4 ELLERDALE CLOSE

DRAWING NAME:  
**PROPOSED FRONT ELEVATION**

PROJECT NO: DRAWING NO: REVISION: SCALE @ SIZE:  
**P1011 PL605 B 1:100 @ A3**  
START DATE: FIRST AUTHOR:  
**APR 2021 MS**

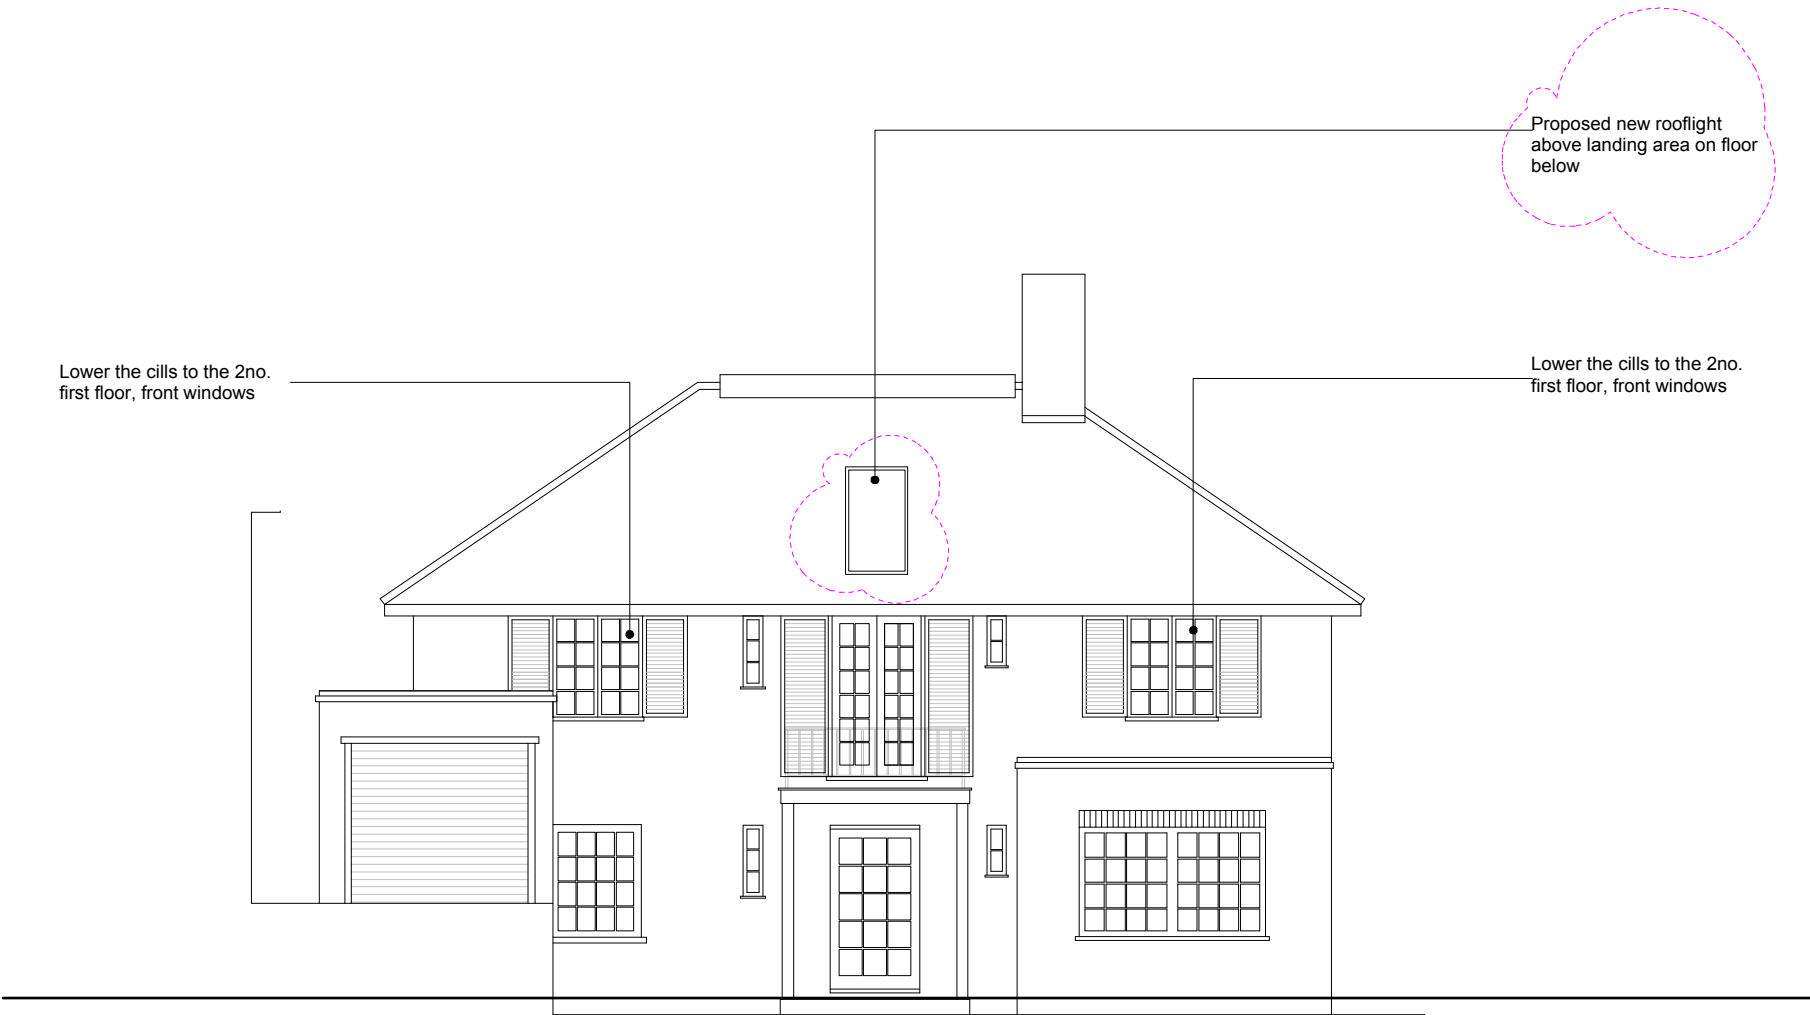
20.04.21	B	Removal of one rooflight from front elevation as requested by planning officer.	MS	GT	
16.04.21	-	First issue	MS	GT	
DATE:	REVISION:	REVISION COMMENTS:	AUTHOR:	CHECKED:
